ADDENDUM NO.: 01
PROJECT NAME: Lincoln Park High School Renovation Project
PROJECT NO.: 05085
CONTRACT NO.: C1582
DATE OF ISSUE: April 27, 2017

NOTICE OF CHANGES, MODIFICATIONS, OR CLARIFICATIONS TO CONTRACT DOCUMENTS

Sheet
M6.02

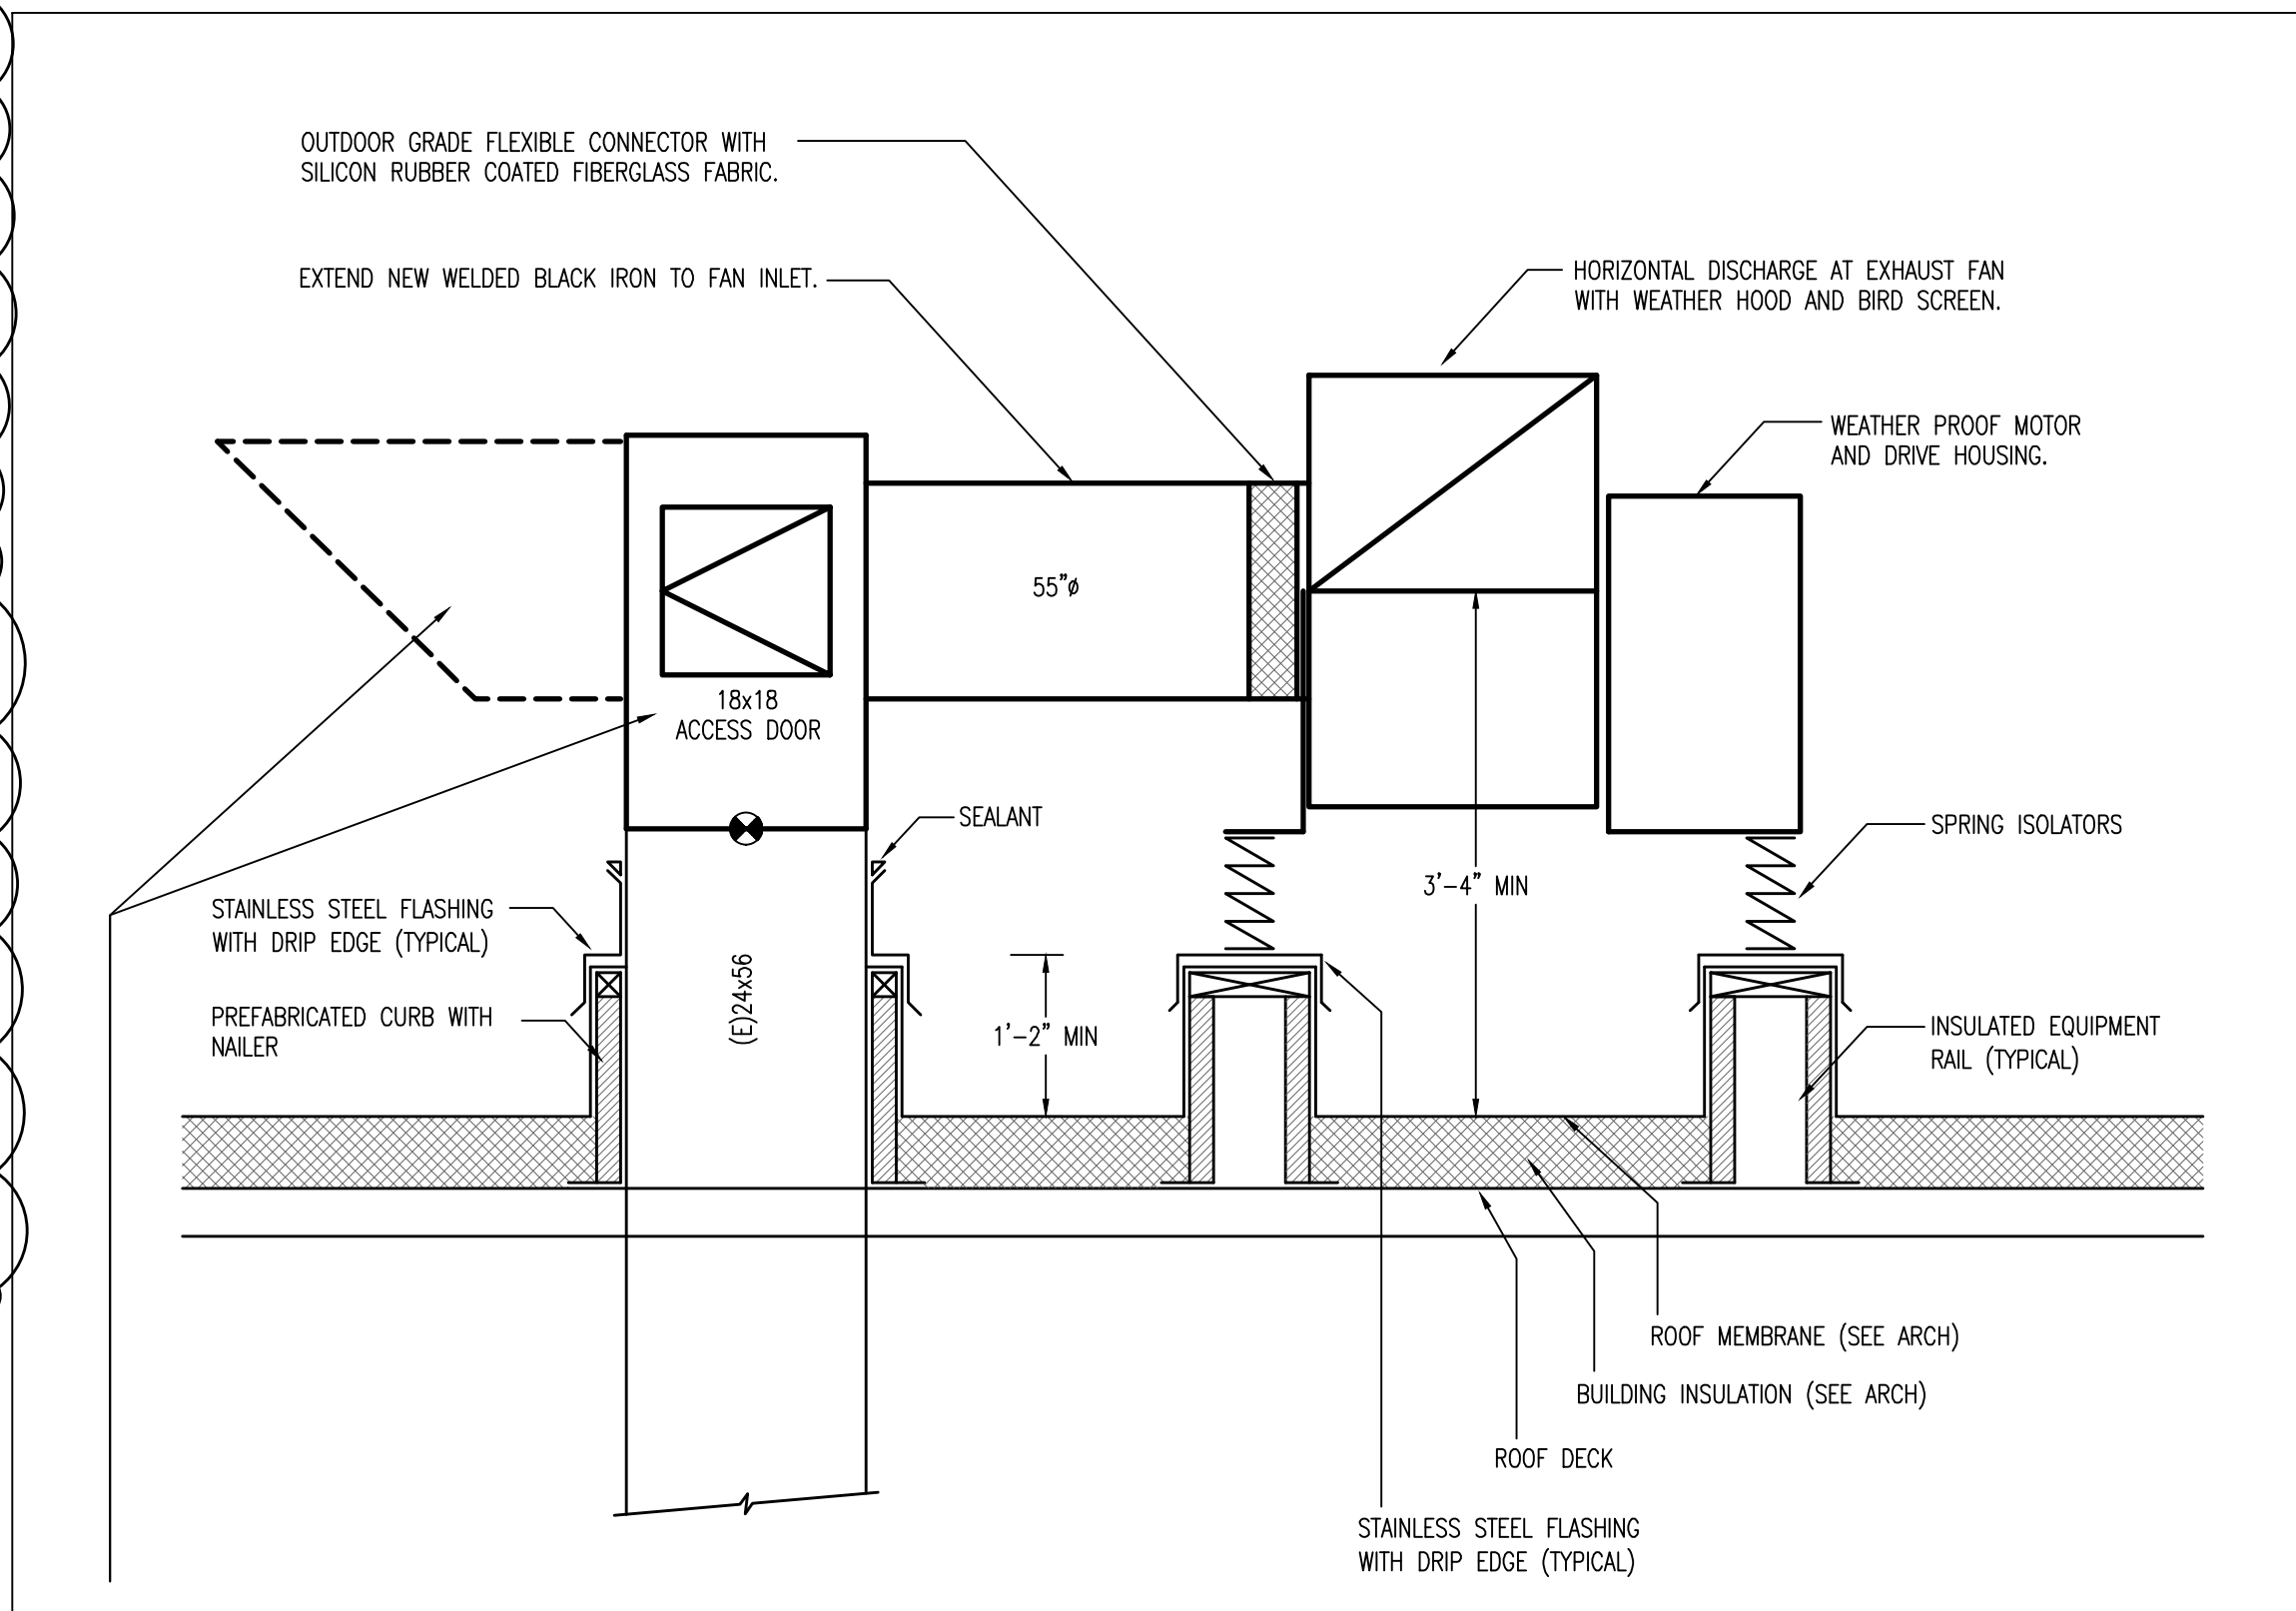
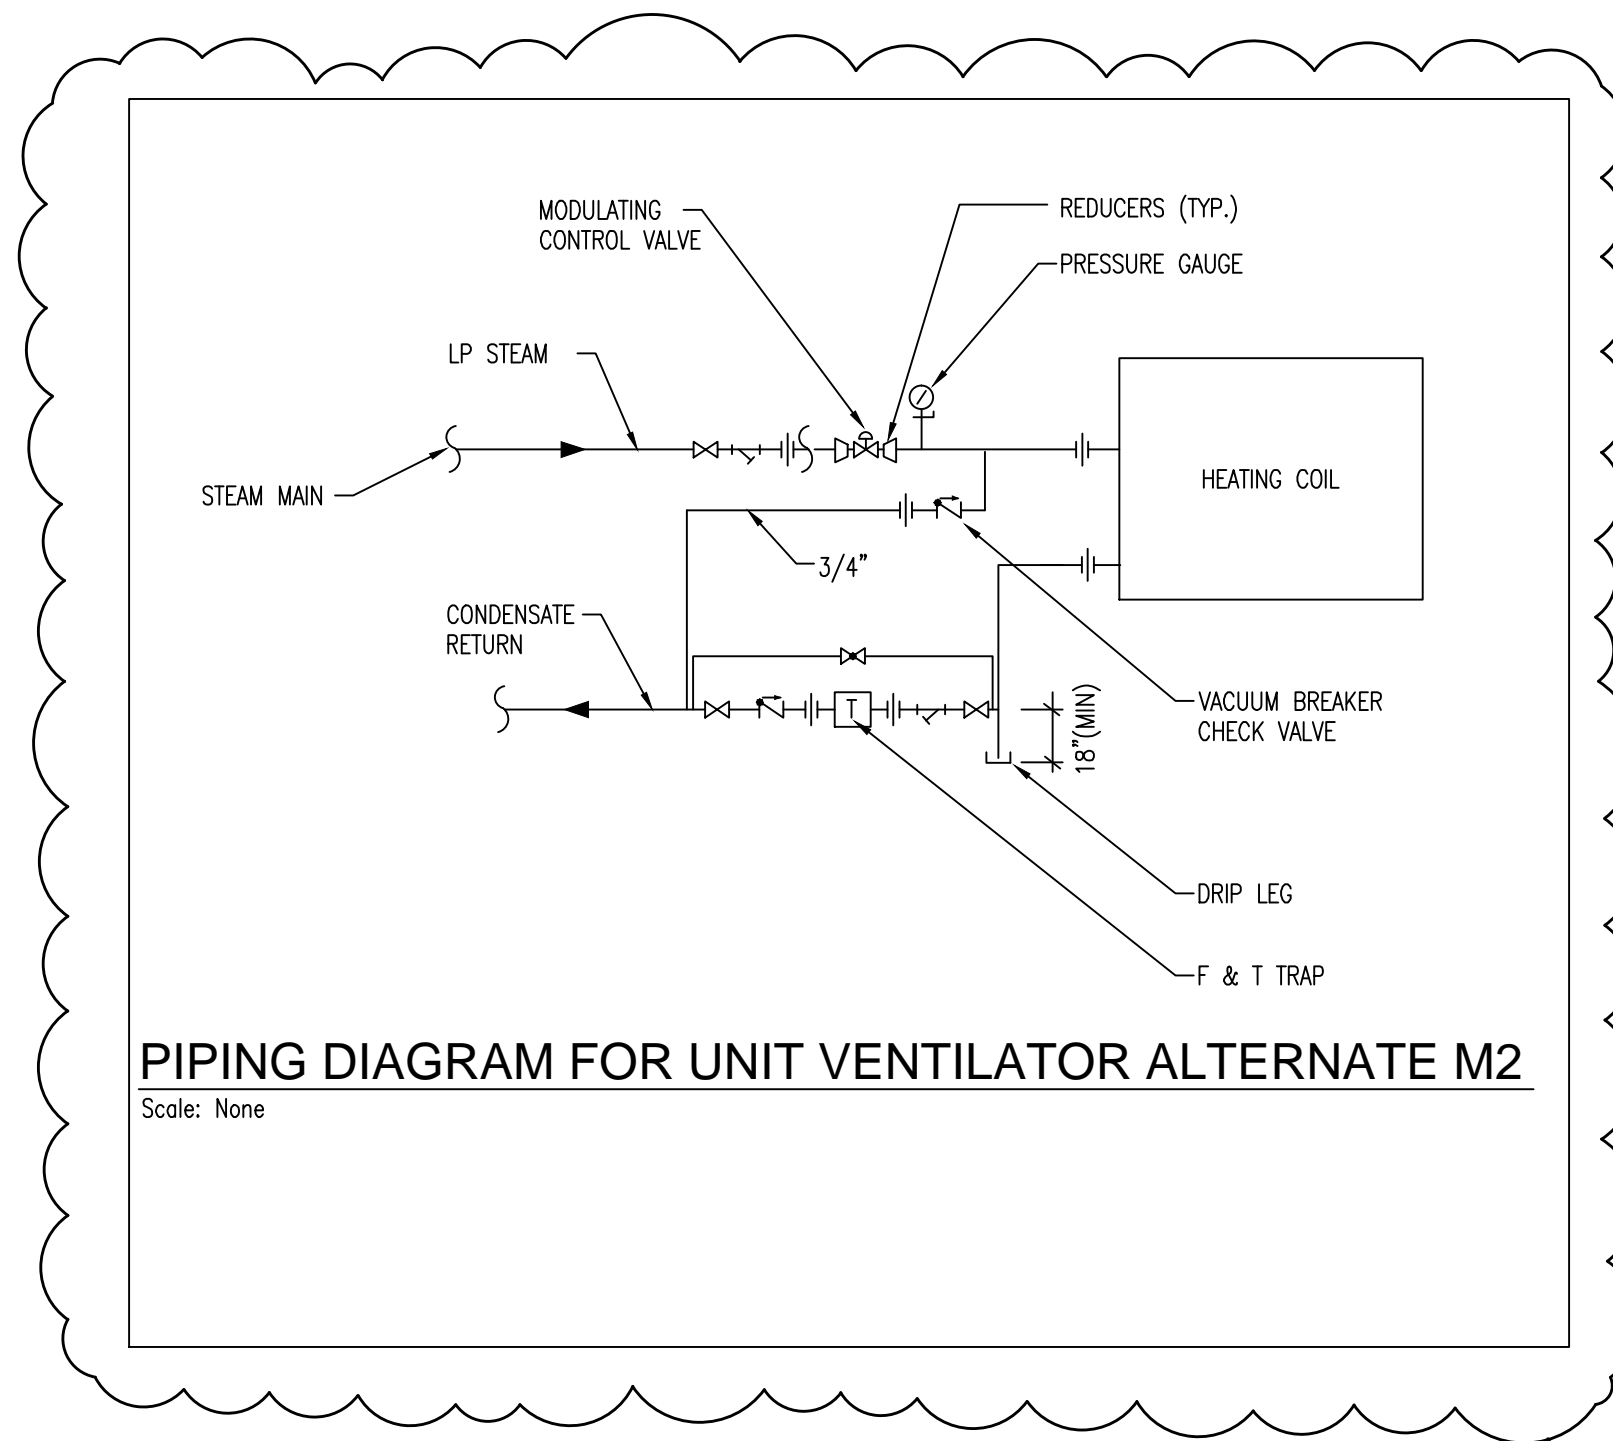
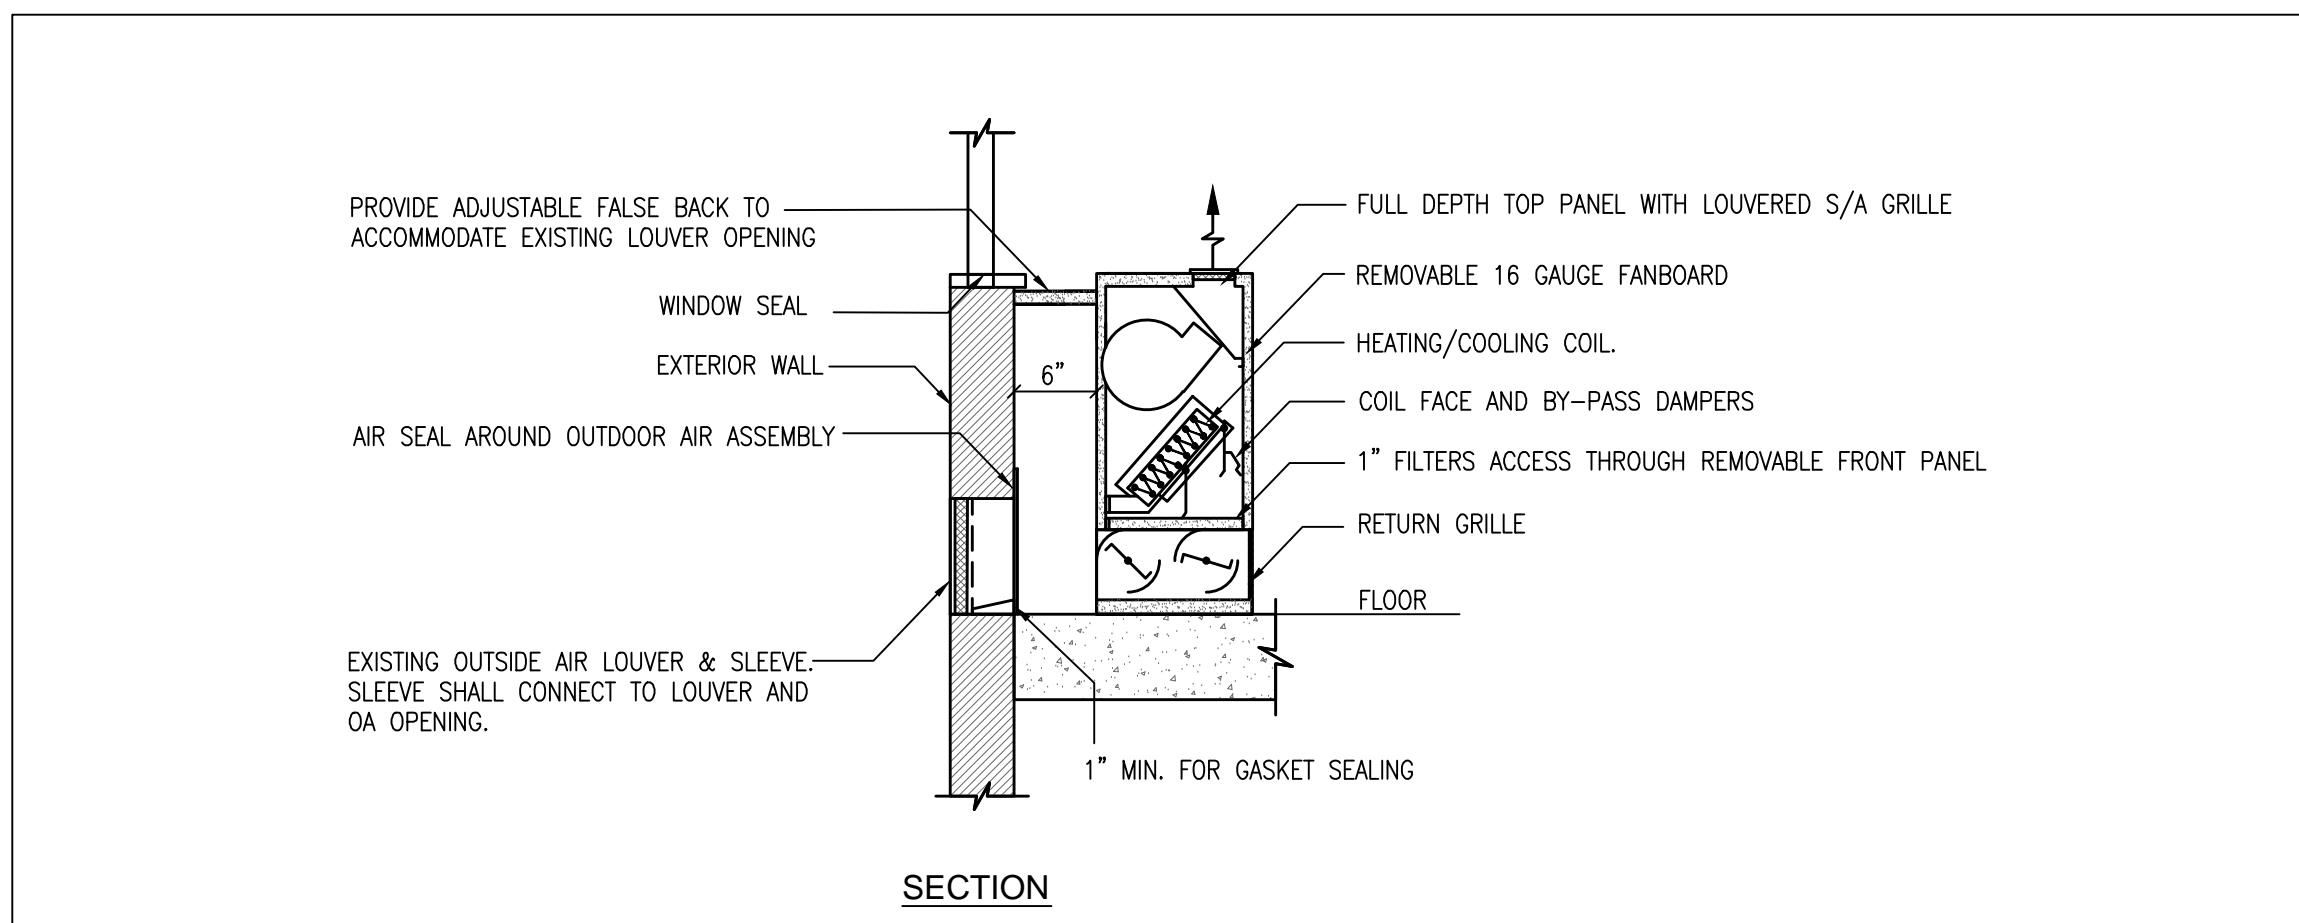
- Change No. 14 Sheet M6.01 ADD: Manufacturer, Model and flow information to Heating Coil Schedule.
- Change No. 15 Sheet M6.02 ADD: Compressed Air Piping Diagram and Piping Diagram for Unit Ventilator.
